SUBJECT: INSPECTION REPORT NO. 70-027/2012-204 AND NOTICE OF VIOLATIONS

REPORT NO.: 70-27/2012-204

LICENSEE: Babcock and Wilcox Nuclear Operations Group, Inc.

### BABCOCK AND WILCOX NUCLEAR OPERATIONS GROUP, INC. U.S. NUCLEAR REGULATORY COMMISSION INSPECTION REPORT 70-27/2012-204

**Figure 1: Model of Unit Surrounded by 12 Inches of Water**

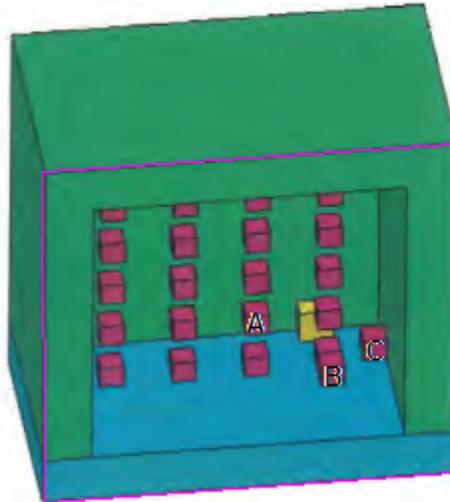
The inspectors questioned the licensee about the effectiveness of the “as necessary” moderator control, given the presence of plastic and similar synthetic moderators in and around the storage cabinets. To address these questions, the licensee performed a revised analysis (NCS-2012-118) of the system. This analysis was performed and sent to the NRC after the exit meeting. The analysis considered polyethylene (plastic) in the storage cabinets. However, the analysis didn’t appear to consider polyethylene in other credible locations, such as near the cabinets. The analysis shows that mixtures of polyethylene and water are bounded by the optimum moderation. The licensee’s analysis of polyethylene in the cabinets does not exceed the 0.92 limit without the presence of water, even when the ‘Law of Substitution’ is applied.

The licensee also analyzed the storage cabinets using an alternate method of accounting for neutron interaction, which can be applied to neutronically isolated units. Until questions from the inspectors lead to the revised analysis, the licensee had not recognized that the license permitted another method of modeling neutron interaction by surrounding a unit in 12 inches of water reflector. This method is discussed in Section 5.2.2 of the license, which states that: “Individual fuel units which are safe by themselves must be evaluated to determine the extent of the neutron interaction between other fuel units in an array. Units will be considered isolated from each other if the increase in K-effective of a unit, due to the presence of another fuel unit, is equal to or less than a K-effective when the presence of an identical unit is separated from the first by twelve inches of water.” As worded, this is not clear as it is comparing “the increase in K-effective” to “K-effective.” It also is not clear how this should be applied. An example of how the licensee modeled the “unit” and the “12 inches of water,” is shown below (adapted from NCS-2012-118, Figure 6). The unit was modeled as being composed of the bread pans in a cabinet (the A blocks), a bread pan in-transit (B block), a bread pan

outside of the room (C block), and a 350 gram  $^{235}\text{U}$  unit (the yellow block) to account for material in a nearby room. A reflective boundary condition was applied (the pink face of the model) so that the unit includes 'a mirror image' of the same configuration for the other cabinet. The unit was placed on a concrete floor (blue material) and surrounded by 12 inches of water (green material).

With this alternate method of modeling interaction, the new bread pan design would still meet the Safety Limit because the worst-case upset would not exceed the 0.95 limit. In addition, the normal case is below 0.92. Therefore, the licensee retracted the EN on August 6, 2012.
